From: [Richard Lauckhart](#)
To: [UTC DL Records Center](#)
Cc: david.danner@utc.wa.gov; [Rendahl, Ann \(UTC\)](#); [Balasbas, Jay \(UTC\)](#); [Nightingale, David \(UTC\)](#); [Johnson, Steven \(UTC\)](#)
Subject: Further comments/documents for the record in Docket No. UE-160918
Date: Wednesday, February 21, 2018 3:06:19 AM
Attachments: [Richard Lauckhart Comments made at WUTC Public Meeting February 21 red letters for speaking.docx](#)
[NERC TPL-001-4.pdf](#)
[Supporting Attachment 2.pdf](#)
[UE-160918 Rebuttal to PSE Criticisms of the Lauckhart-Schiffman Load Flow Study.pdf](#)

Please file this email and its three attachments as comments under PSE IRP Docket No. UE-160918.

Richard Lauckhart Comments made at WUTC Public Meeting February 21, 2018 re PSE IRP

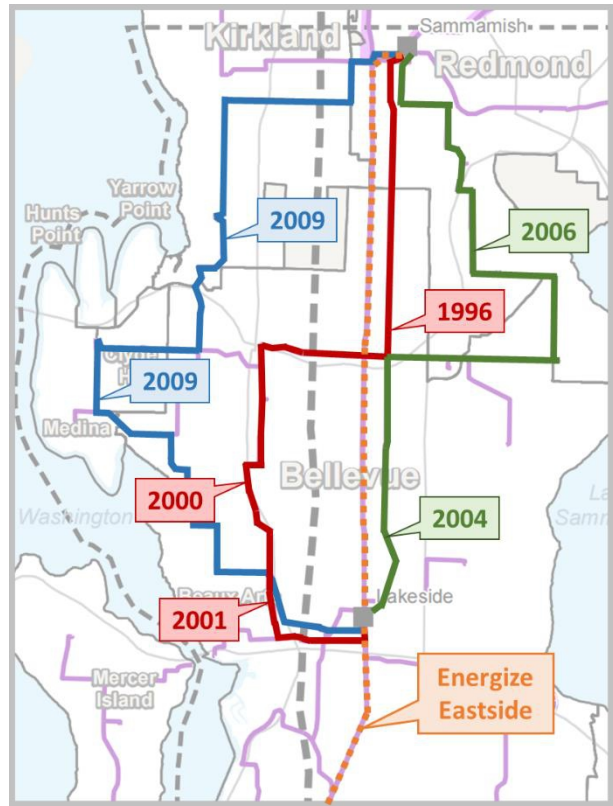
4. We challenge PSE to explain how they solved issues that arise from their scenario with the electrical limits of the “West of Cascades-North” transmission lines.

- We have asked for PSE’s study data so we can determine whether PSE solved this problem or simply ignored it. PSE has refused to share the data. **Until PSE provides these files, PSE’s load flow studies should not be considered adequately vetted for purposes of approving or permitting the Energize Eastside project.**

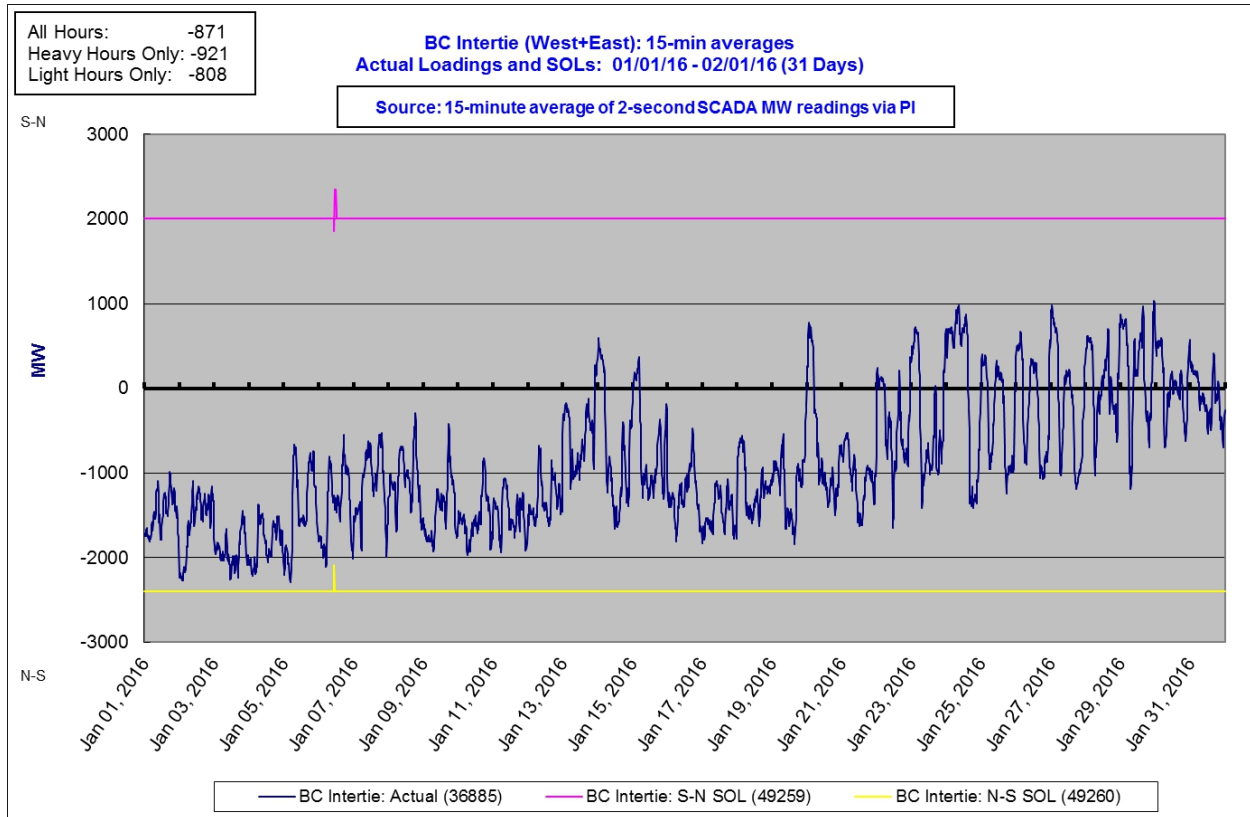
One fact is beyond dispute. Turning off 1,400 MW of generation in the Puget Sound area would require that amount of electricity to be imported from central Washington (since PSE insists that it can’t come from Canada). We believe that the transmission lines carrying electricity from central Washington do not have sufficient capacity to deliver that additional power along with 1,500 MW to Canada. Once again, this is an unrealistic scenario.

6. We challenge PSE to cite standards that require them to turn off 6 local generation plants at the same time they are serving peak demand with an N-1-1 contingency.

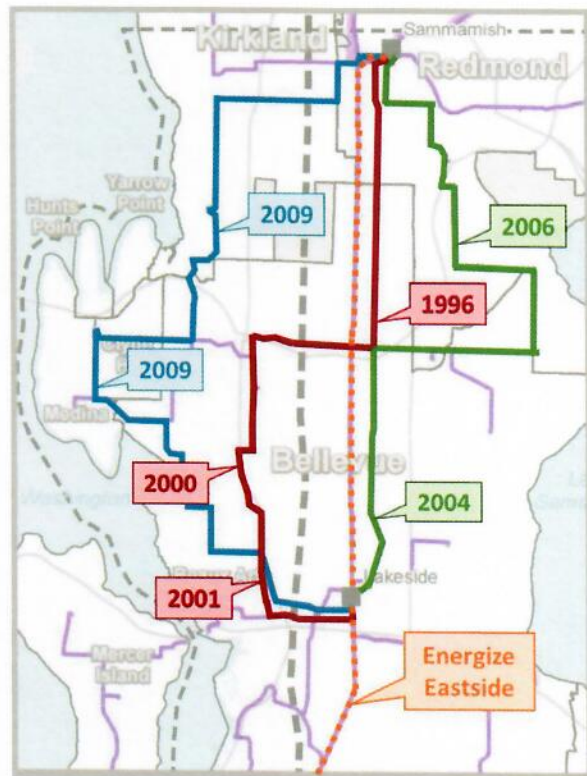
4. We challenge PSE to explain how they solved issues that arise from their scenario with the electrical limits of the “West of Cascades-North” transmission lines.

- We have asked for PSE’s study data so we can determine whether PSE solved this problem or simply ignored it. PSE has refused to share the data. **Until PSE provides these files, PSE’s load flow studies should not be considered adequately vetted for purposes of approving or permitting the Energize Eastside project.**

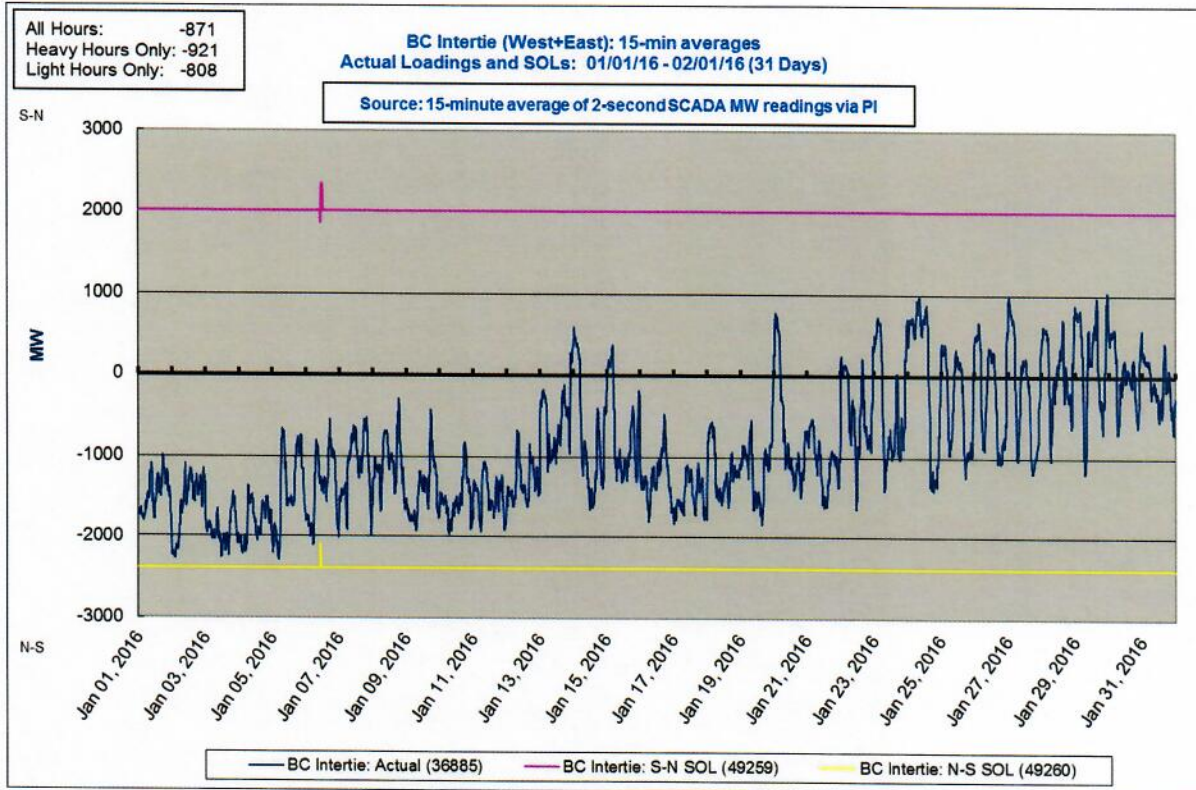
One fact is beyond dispute. Turning off 1,400 MW of generation in the Puget Sound area would require that amount of electricity to be imported from central Washington (since PSE insists that it can’t come from Canada). We believe that the transmission lines carrying electricity from central Washington do not have sufficient capacity to deliver that additional power along with 1,500 MW to Canada. Once again, this is an unrealistic scenario.

6. We challenge PSE to cite standards that require them to turn off 6 local generation plants at the same time they are serving peak demand with an N-1-1 contingency.
